# SITE 53 -2 FIGTREE DRIVE SYDNEY OLYMPIC PARK

**ACCESS REVIEW**

Morris Goding Accessibility Consulting

FINAL v7

# Figure 1. Main Building Entries / Address

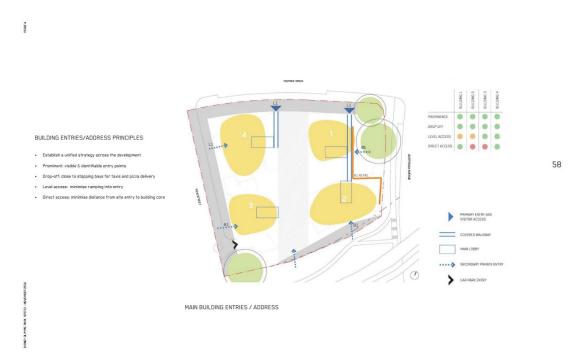
An accessible path of travel from the two principal public pedestrian entry points on Figtree Drive footpath is achievable for all residents and visitors to residential buildings 1-5 via ramps and landscaped landscape podium at level 01 (See Sections 3.5, 3.5 below) as required by BCA/DDA Access Code Part D3.2. An accessible path of travel is also provided to and through at least 50% of other secondary private pedestrian entry points for residents, in line with the intent of BCA/DDA Access Code Part D3.2. It is understood that the existing street levels along Figtree Drive (outside of site boundary) are to be regraded/improved by others.

Due to the existing site topography and street levels that have been driven by the Masterplan, there is a significant height variation from the existing Linear Park southern boundary to the existing northern boundary at the top of New Street (8.9M height variation) and landscape podium, level 01. The secondary private pedestrian stair entry for residents to the landscape podium from this approach is therefore not accessible for residents with mobility impairment. However an alternate accessible pedestrian route from this approach is proposed and achievable via a series of 1:20 walkways that will connect Linear Park in the south to the lower part of New Street in the west. The secondary private pedestrian stair entry for residents from Linear Park will be designed to comply with AS1428.1 with appropriate set-backs and access features for improved safety and access for people with ambulant and sensory disability.

The proposed accessible walkway from Linear Park is an improvement that will provide public access between these areas at all times (walkways located outside secure line of residential site), and an alternate accessible (step-free) path of travel for private residents to landscape podium, level 01, through the Building 3 lift lobby, level B01. The base of the proposed new walkway is within reasonable proximity to the base of the stairs (50m max. distance), which will satisfy the intent of BCA Clause D3.2. The proximity of the proposed walkway to New Street vehicular basement entry/exit point to development will require further review during design development, prior to Construction Certificate, to ensure compliance and pedestrian safety is maintained.

- (i) Ensure the walkway and connecting path of travel leading to Building 3 lift lobby, level B01 from Linear Park and the site allotment boundary is developed in accordance with AS1428.1 to ensure an equitable accessible route (in lieu of southern stairs) to the landscape podium (level 01), compliant with BCA/DDA Access Code.
- (ii) Ensure all stairways are suitably set-back at top and base areas for handrails on both sides that do not protrude into transverse paths of travel, compliant with BCA/DDA Access Code.
- (iii) Ensure there are continuous accessible paths of travel to and within public domain areas within the site boundary that connect to existing pedestrian network in line with the requirements of the SOPA Masterplan 2030 Chapter 4.3.
